Form 3160-5
(June 2019)UNITED STATES
DEPARTMENT OF THE INTERIOR
BUREAU OF LAND MANAGEMENTFORM APPROVED
OMB No. 1004-0137
Expires: October 31, 2021**SUNDRY NOTICES AND REPORTS ON WELLS**
Do not use this form for proposals to drill or to re-enter an abandoned well. Use Form 3160-3 (APD) for such proposals.

8. Well Name and No. STARK 33 FED COM/703H

EOG respectfully requests an amendment to our approved APD for this well to reflect the following changes:

Stark 33 Fed Com 723H (FKA 703H) API #: 30-015-48600

Proposed Wellbore

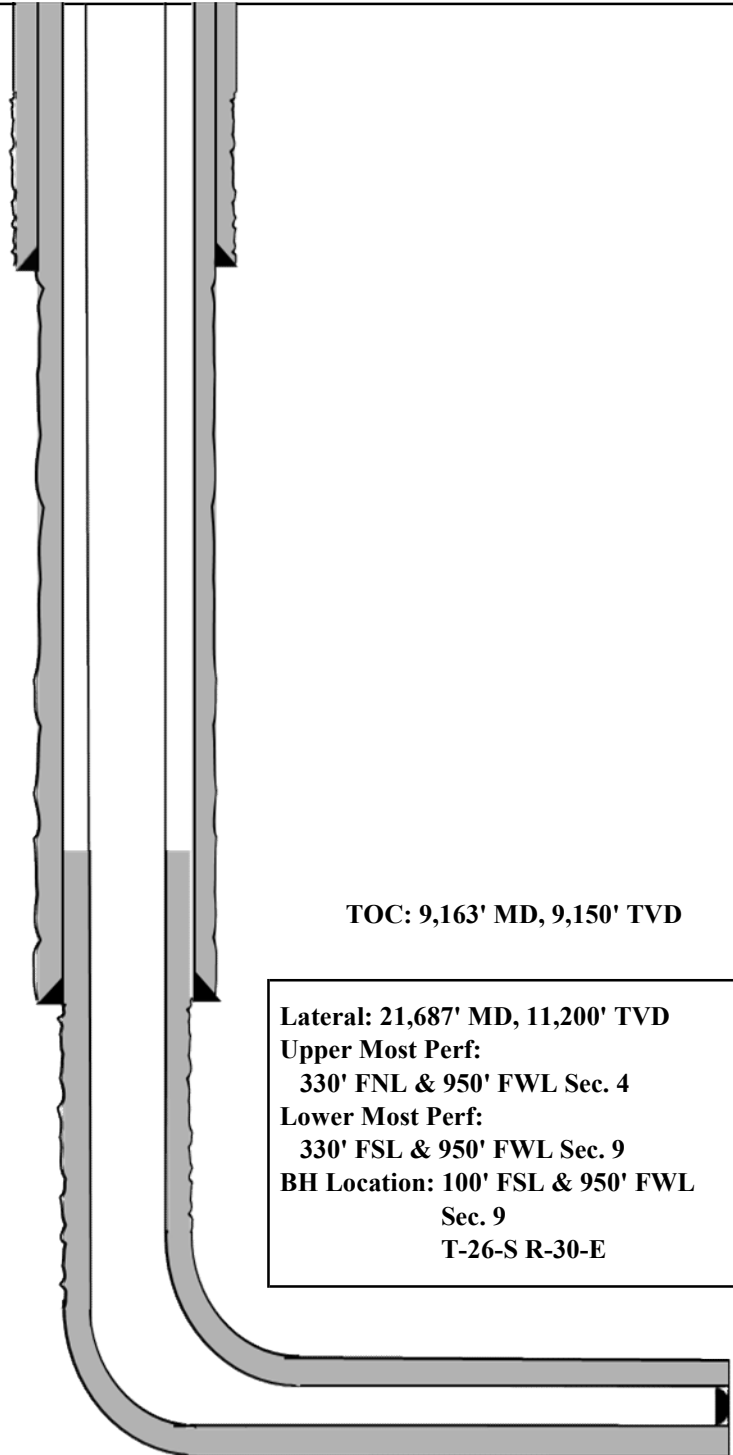
Design B**4. CASING PROGRAM**

Hole Size	Interval MD		Interval TVD		Csg OD	Weight	Grade	Conn
	From (ft)	To (ft)	From (ft)	To (ft)				
13"	0	1,150	0	1,150	10-3/4"	40.5#	J-55	STC
9-7/8"	0	9,663	0	9,650	8-3/4"	38.5#	P110-EC	Vam Sprint-SF
7-7/8"	0	21,687	0	10,722	6"	24#	P110-HP	Eagle SFH SC

Variance is requested to waive the centralizer requirements for the 8-3/4" casing in the 9-7/8" hole size. An expansion additive will be utilized, in the cement slurry, for the entire length of the 9-7/8" hole interval to maximize cement bond and zonal isolation.

Variance is also requested to waive any centralizer requirements for the 6" casing in the 7-7/8" hole size. An expansion additive will be utilized, in the cement slurry, for the entire length of the 7-7/8" hole interval to maximize cement bond and zonal isolation.

Variance is also requested to waive the annular clearance requirements for the 6" casing by 8-3/4" casing annulus to the proposed top of cement.

Bit Size: 13"
10-3/4", 40.5#, J-55, STC,
@ 0' - 1,150'

Bit Size: 9-7/8"
8-3/4" 38.5#, P110-EC, Vam Sprint-SF,
@ 0' - 9,663'

Bit Size: 7-7/8"
6", 24#, P110-HP, Eagle SFH SC,
@ 0' - 21,687'

Plan #0.2

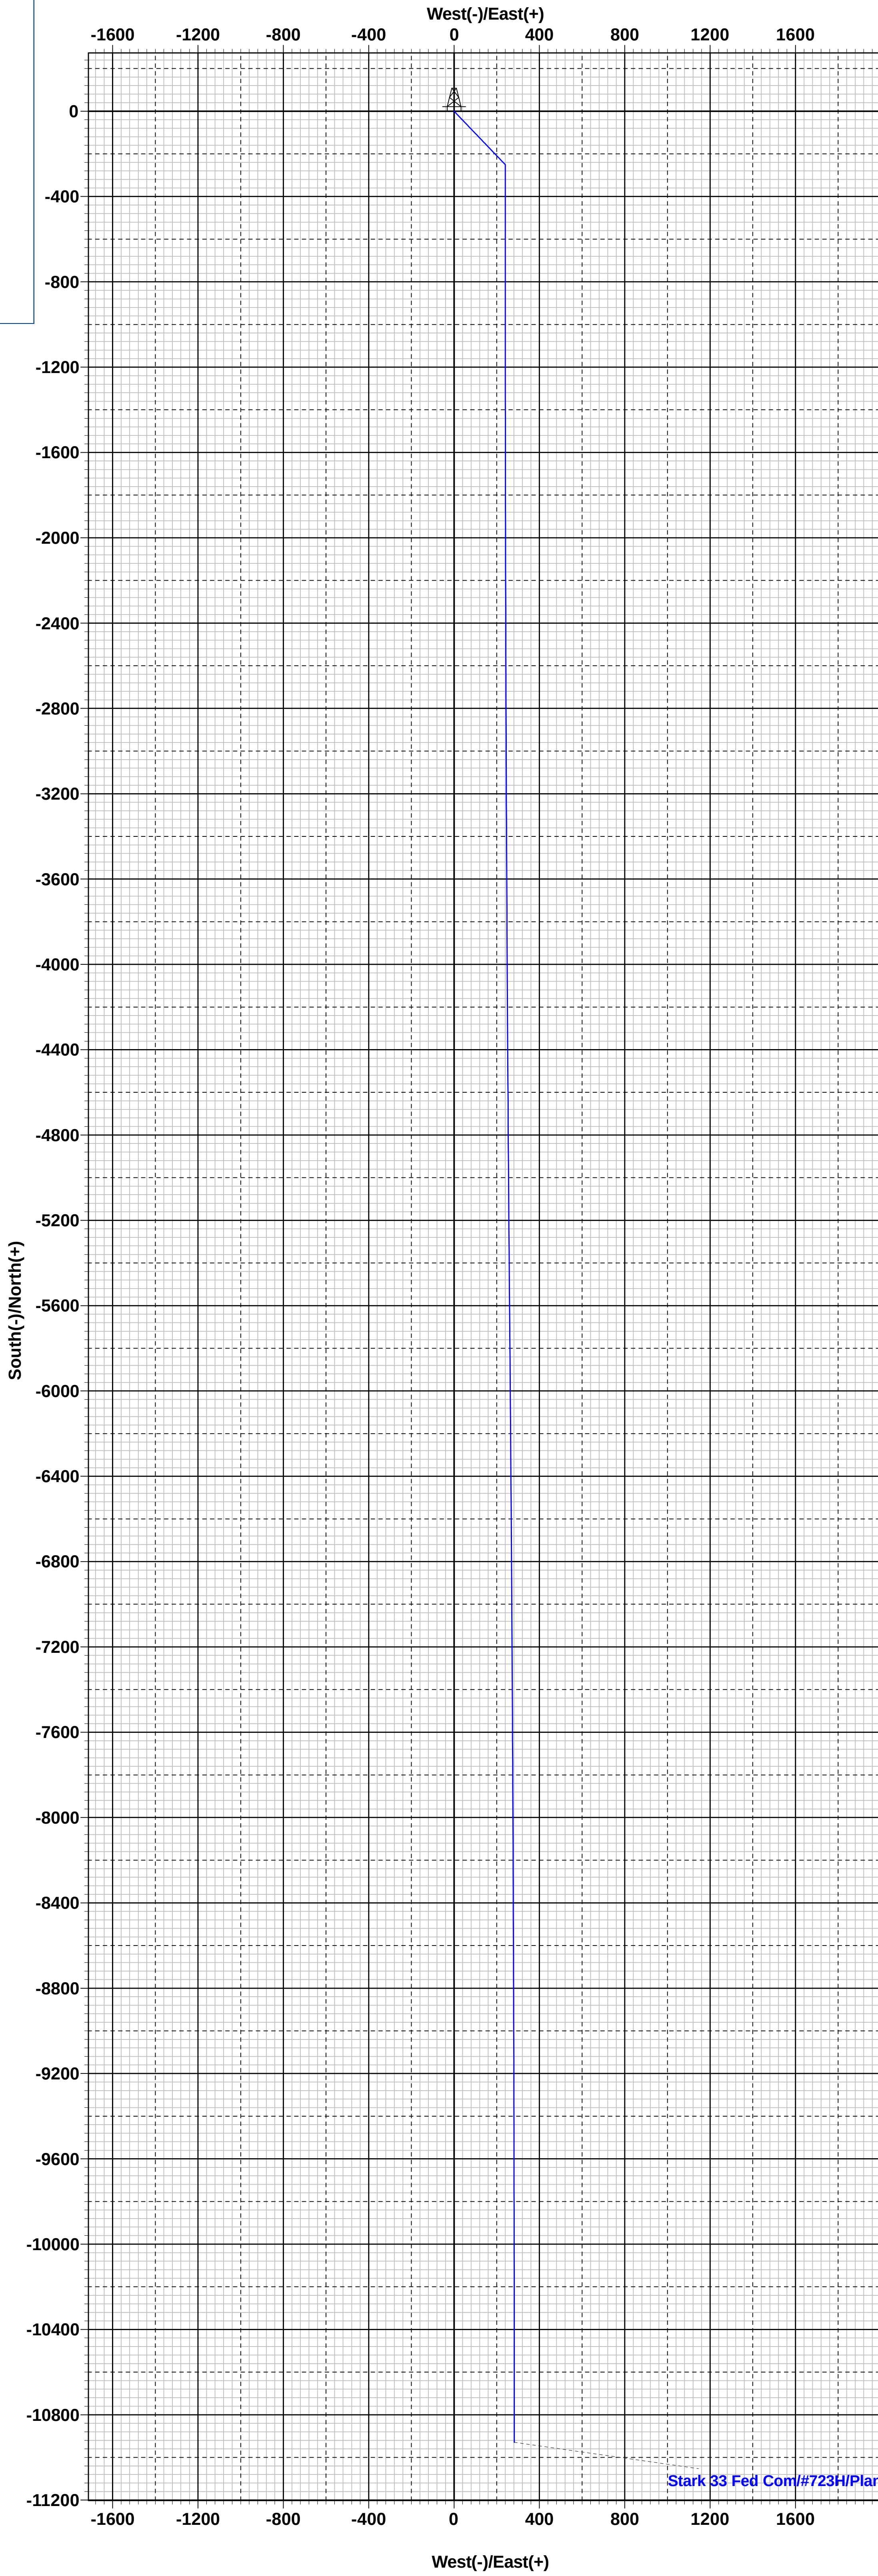
Change BHL from T-26-S, R-30-E, Sec 9, 2427' FNL, 1130' FWL, Eddy Co., NM, to T-26-S, R-30-E, Sec 9, 100' FSL, 950' FWL, Eddy Co., N.M.
